ACTION OF THE ZONING ADMINISTRATOR

On Wednesday, November 12, 2003, the Zoning Administrator approved with conditions a plan review to construct a new commercial building for the project known as Z03-288. Findings of Fact and conditions of approval for the project are listed on pages 3-7.

Request: **Zoning Administrator Plan Review** to construct a 7,055 square foot commercial building on 0.86± vacant acres in the General Commercial-Review (C-2-R) zone.

Location: 2811 Florin Road (D5, Area 3)

SITE PLAN
 1/8" = 1'-0"

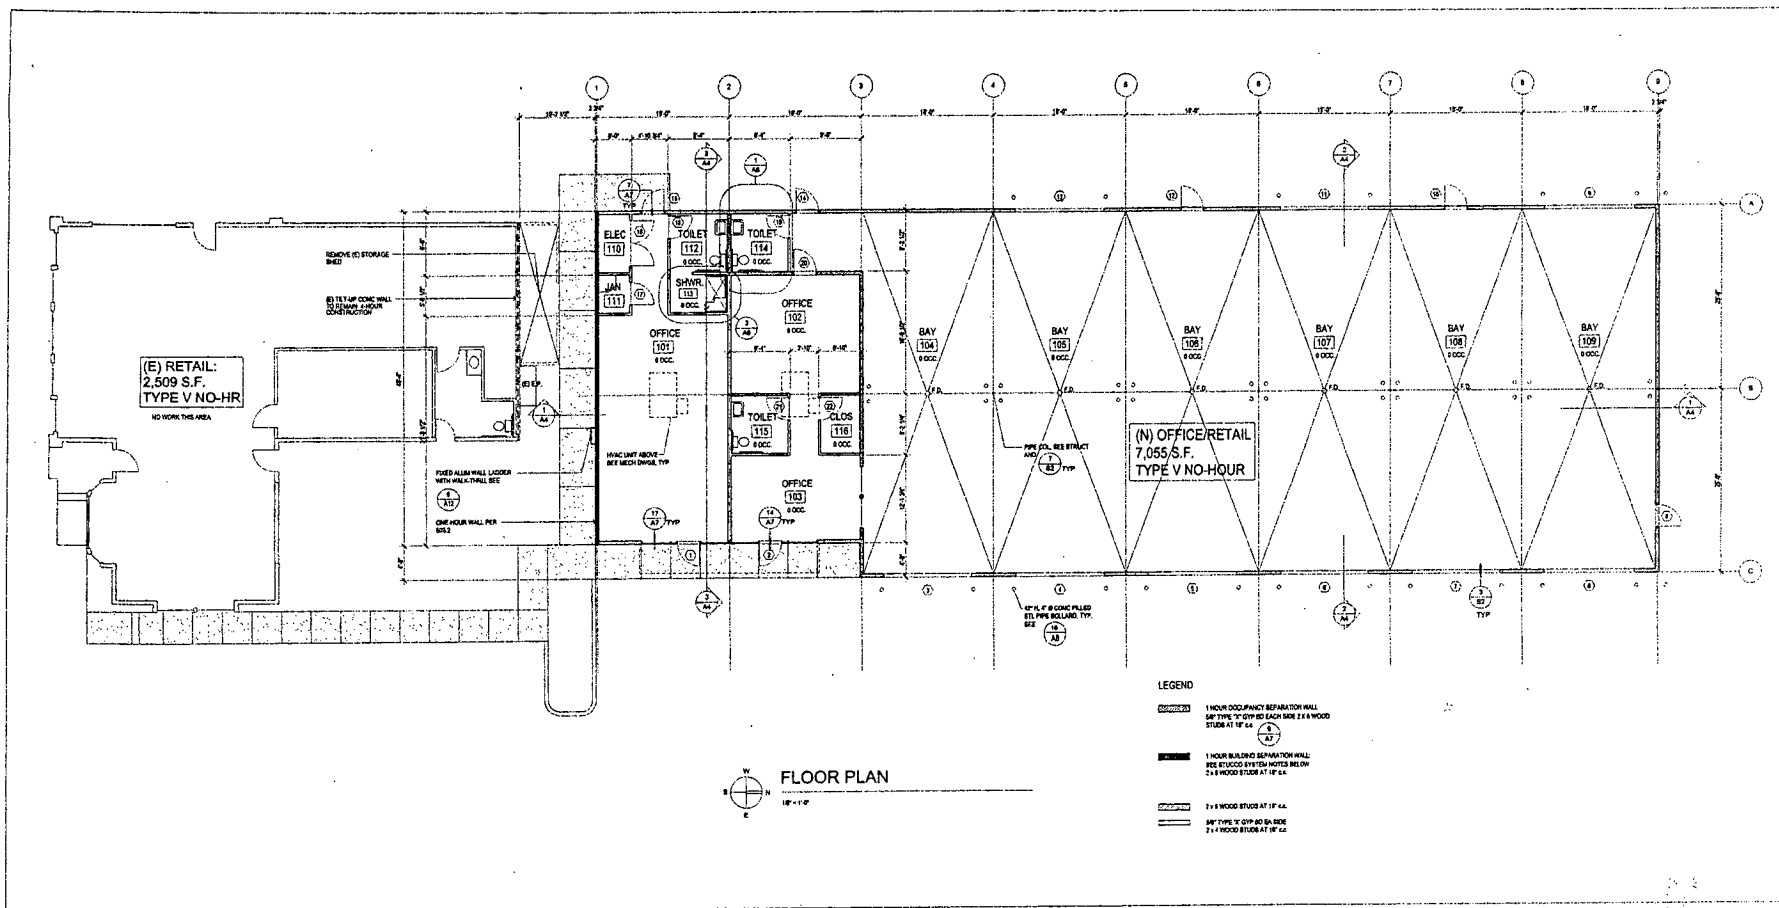
The proposed site plan indicates the site will have adequate fire access and circulation. The proposed project meets all setback and parking space requirements. The existing retail use requires one parking space for every 200 gross square feet of retail space or 13 spaces and the new building requires a total of 15 spaces. Eleven spaces are required for the servicing area based on one space for every 500 gross square feet and four spaces are required for the office area based on one space for every 400 gross square feet. There are all 19 existing spaces and 16 proposed spaces for a total of 35 spaces. The existing spaces do not meet the current tree shading requirements per the Zoning Code and will be required to meet current standards because the new structure will result in over 50 percent of the site being newly paved. Several spaces may be lost to meet the shading requirements. The project is also required to provide one bicycle parking space.

1. The applicant shall meet the shading requirements for the parking and paved areas (this includes the existing parking area also per the Zoning Code).
2. One bicycle parking space shall be provided on site and shall be a Class 1 facility.
3. If dumpsters are used, they must be stored inside a trash enclosure. The trash enclosure shall be built to the standards in the Zoning Code. The enclosures shall provide adequate receptacles for

4. The trash enclosure shall be built to the standards of the Zoning Code. The enclosures shall provide adequate receptacles for recycling in accordance with the recycling requirements of the Zoning Code. The masonry walls shall be six feet in height, constructed of split face block, color to complement the proposed building. Gates shall be constructed of decorative solid heavy gauge metal and be designed with cane bolts to secure the gates when in the open and closed positions. A minimum of 10 feet wide and 20 feet long concrete apron shall be provided in front of the enclosure. If the container will be crane lifted, the minimum width shall be 15 feet.

19. Repair or replace/reconstruct any existing deteriorated curb, gutter and sidewalk fronting Florin Road per City standards to the satisfaction of the Department of Public Works.
20. The subject site shall conform to A.D.A. requirements in all respects.
21. The subject site shall conform to the parking requirements set forth in chapter 17 of City Code (Zoning Code).
22. All new and existing driveways shall be designed and constructed to City Standards to the satisfaction of the Department of Public Works. The eastern most driveway shall be reduce to the maximum 35-foot width, per City of Sacramento code.
